BOUNTIFUL CITY PLANNING COMMISSION AGENDA TUESDAY, DECEMBER 3, 2024 6:30 P.M.

Planning Commission Staff Report

Subject: Final Architectural and Site Plan for

Construction Services without Outdoor

SITE PLAN AS101

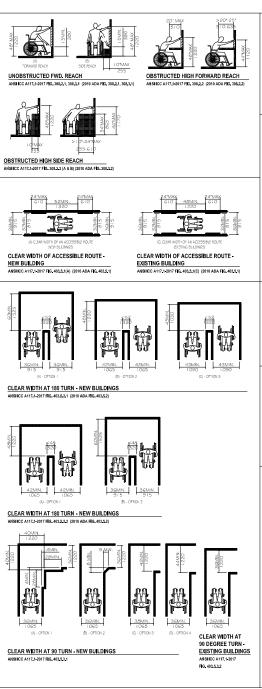
Maintain the vegetated screening along the residentially a property boundary. If substantial removal of this existing vegetation occurs, the property is required to meet the fol Code 14-16-111(E): a solid screening device or wall of nasonry, wood, vinyl or similar material shall be constructed along property lines which are located within twenty (20) feet o a residential dwelling or zone. Such wall shall be a minimum of six (6) feet in height, except for areas within twenty (20) feet of a public street property line, where it shall be the maximum height allowed in a single-family residential zone.
